TMDSEVM6474L Known Issues

- 1. Potential SERDES Clocking issue in TMS320C6474
- 2. Version number displayed on UART console during POST execution
- 3. Intermittent DDR2 data corruption

Figure 1. Location of R94 -- Bottom side of PCB near U32

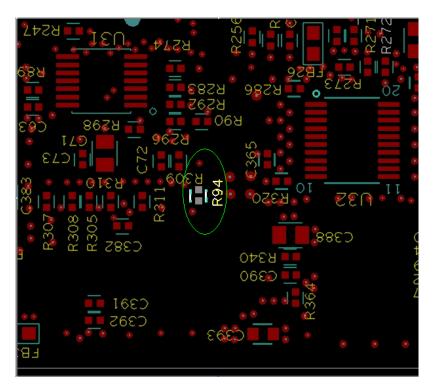
Details: A bug has been found in the SerDes interfaces of TMS320C6474 that causes a SerDes clocking problem in normal functional operation. This problem will not occur when external pull-down is applied on the TCK pin (JTAG controller clock). SerDes are used in the Ethernet interface (EMAC), Serial RapidIO® interface (SRIO) and the Antenna Interface (AIF).

The TCK pin (JTAG controller clock) is internally assigned to an internal signal that is used by the SerDes macro. For the SerDes macro to get proper clocking in the normal functional operation, it needs the internal signal to be held low. However, there is an internal pull-up on the TCK, creating problems for SerDes operation. This problem exists on all SerDes interfaces.

In TMDSEVM6474L this issue may cause EMAC loop back test to fail randomly during Power On Self Test (POST).

1. Un-mount pull up resistor R94 (4.7K) from net TG_TCK. Refer below figure for the location of R94.

Figure 2. Location of TCK (U32.20) net and nearest GND nodes -- Bottom side of PCB

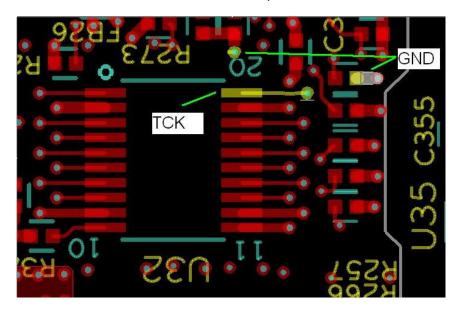
A pull down is needed on TCK, to do that:

2. Add 1K pull down resistor on net TCK (U32.20). Refer below figure for the location of TCK net and nearest GND node for the addition of pull down resistor between them.
